Access Compliance Report Public Rights-of-Way (Curb Ramps)

Main Street: PROSPECT_AVE Cross Street: WHITNEY_DR Location: NE

ADA ID: RPAT211022143050 Ramp Type: Type 1 - Perpendicular Diagonal Initial Pass/Fail: Pass Overall Compliance: No Severity Score: 0

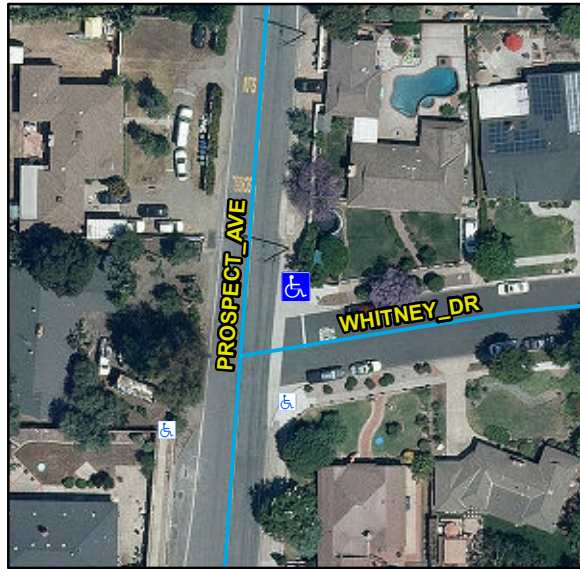
R304.2.2, R304.2.1, STD 1115

Remove & Replace Curb Ramp With Two New Directional Ramps or Equivalent.
